# UNITED STATES PATENT AND TRADEMARK OFFICE

APPLICATION NO.	FILING DATE	FIRST NAMED INVENTOR	ATTORNEY DOCKET NO.	CONFIRMATION NO.
10/005,000	12/07/2001	James H. Lee	H-204145	1829

<b>Office Action Summary</b>	<b>Application No.</b>	<b>Applicant(s)</b>	
	10/005,000	LEE ET AL.	
	<b>Examiner</b>	<b>Art Unit</b>	
	Raymond Alejandro	1745

## DETAILED ACTION

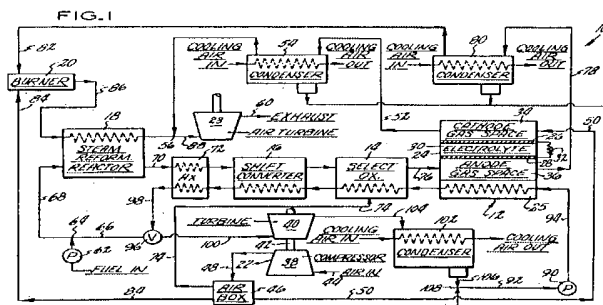
Bloomfield discloses a fuel cell power plant (TITLE) comprising as shown in **Figure 1** below a pump 90 delivering water via a conduit 92 into thermal exchange relationship with stack 12 via a conduit 94 by passing the water through the thermal exchange portion 25 of the stack (COL 5, lines 28-32). It is disclosed the fuel cells comprises a single cell 24 and a thermal

management portion 25 (COL 3, lines 23-27). Bloomfield discloses that the liquid is increased in pressure by pumps (COL 4, lines 1-5). Bloomfield further discloses that part of the water is changed to steam as it passes through the stack 12. The water and steam is superheated by passing it into heat exchange relationship with the fuel conditioning apparatus. It is further heated in the selective oxidizer 14 and the shift converter 16 and in the heat exchanger 72 (COL 5, lines 32-40). The steam then leaves the heat exchanger 72 and is delivered to a valve 96. Then, the remainder of the superheated stream is delivered into turbine 40 (the expander) via a conduit 100. The turbine drives the compressor 38 for compressing the air for the stack. The turbine is a steam driven turbine, however, any steam driven engine operably connected to run a compressor may be used (COL 5, lines 40-50).

Bloomfield further teaches that the exhaust from the turbine 40 is delivered into a condenser 102 via a conduit 104. Heat is removed from the steam by passing air through the condenser as shown. Liquid water, or possibly a mixture of liquid water and steams, leaves the condenser 102 via a conduit 106 and is combined at 108 with water recovered from the anode and cathode effluent gas streams in the condensers 54, 80. The water is then delivered to the pump 90 via the conduit 92 and the process starts again (COL 5, lines 50-62). It is disclosed that the amount of water lost in the Rankine cycle loop is recovered in the condensers 54, 80 and which is combined at 108 with the water which recirculates through the loop (COL 6, lines 1-6).

*Hence, Bloomfield teaches the specific pump, heat generating fuel cell system, expander, the compressor (the second fuel cell system component) and the condenser satisfying the specific spatial relationship and functional configuration as instantly claimed.*
